DIST	COUNTY	ROUTE	KILOMETER POST TOTAL PROJECT	SHEET No	TOTAL SHEETS
04	SF	80	13.2/13.9	133R1	1204

CONTRACT CHANGE ORDER NO. 42
SHEET x OF xx

DETAILS
SAS SUPERSTRUCTURE ROADWAY WESTBOUND CONDUIT LOCATIONS
SCALE AS NOTED

E-68

PLAN
CONDUIT STUB-UP PLAN FOR ROADWAY LIGHTING AND MVDS ON METAL BASE
SCALE 1:20

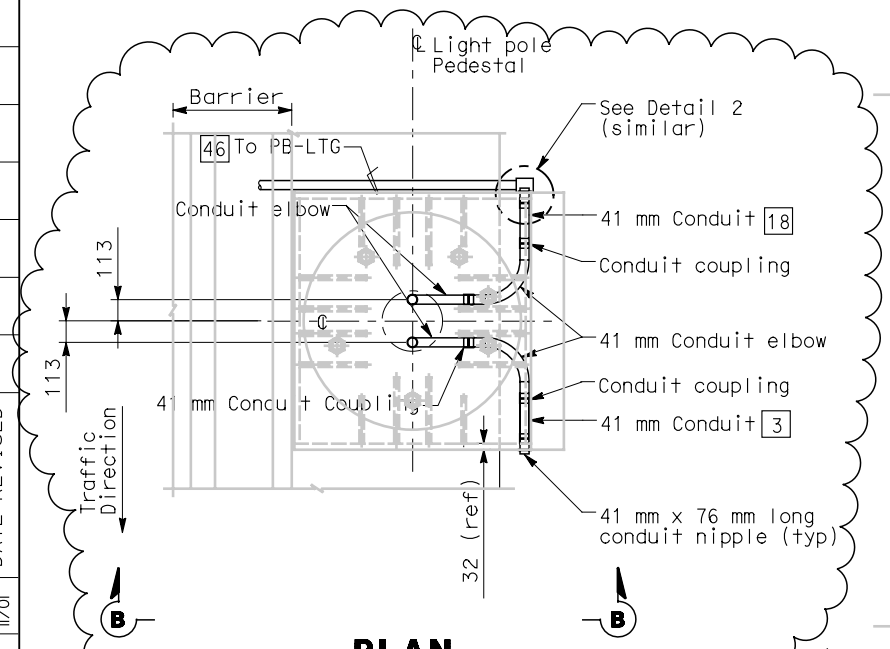
MARK	DATE	DESCRIPTIONS	BY	CK	CCO
1	8-06-07	Revision to misc. electric work. Change roadway barrier receptacle type per RFI-242. Change conduit sizes inside light pole and types from MVDS per RFI-565. RFI-261 is superseded by RFI-565.	MP EL	RR	42
